Turbo HD DVR V3.5.22 Build170927 Release Notes (2017-09-30)

Firmware Version:	V3.5.22 Build170927		
	SDK Version:	V5.2.7.30 build20170428		
Firmware	Play Library (PlayCtrl.dll)	7.3.2.0		
Basic Information	player	4.8mini		
	Web version	V4.0.1 build 170419		
	Client version	V2.5.8.101 build20170426

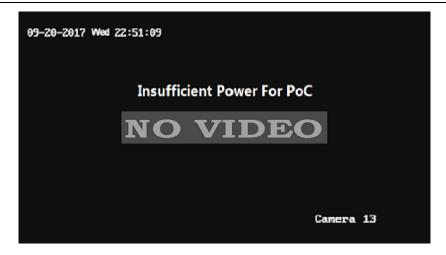
2. Newly support prompt on live view when there are not enough power supply for PoC cameras connected
